01314-01691 Version 4

Product Update: Driver's Door Lock Actuator

Supersedes 14-083, dated March 7, 2015, to revise the information highlighted in **yellow**

REVISION SUMMARY

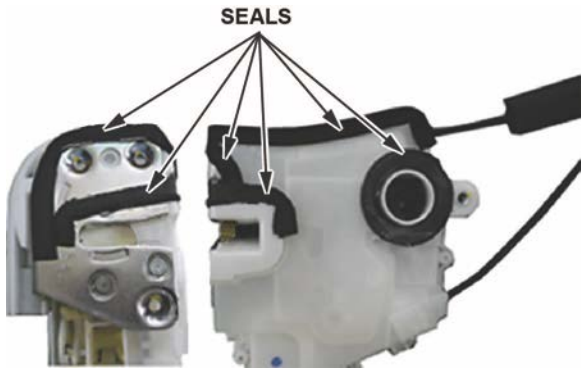
REVISED IMAGE

4. Remove the driver's door latch assembly.

5. Remove all the seals from the latch assembly.

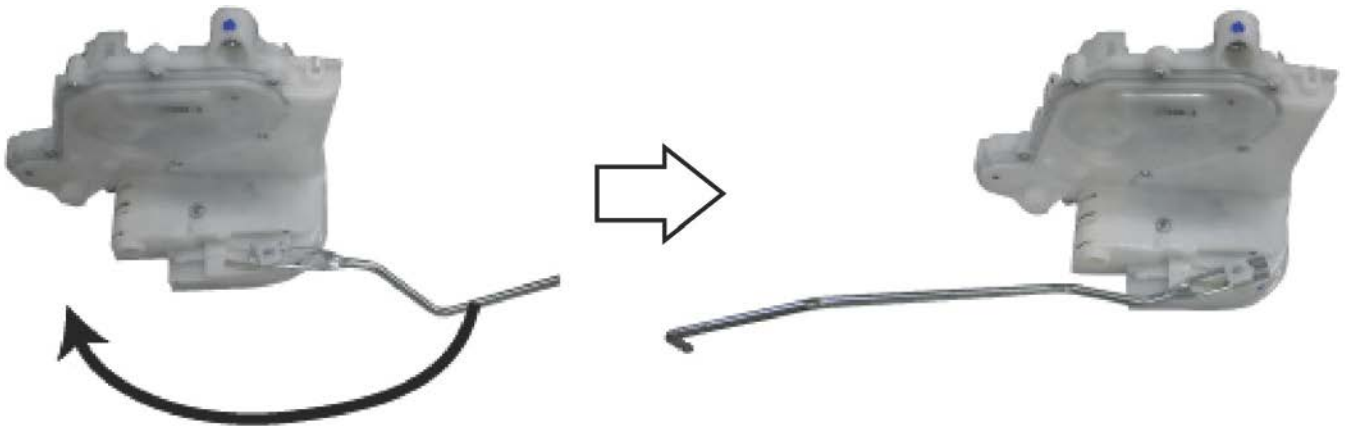
REVISED IMAGE

6. Detach the outer handle rod.
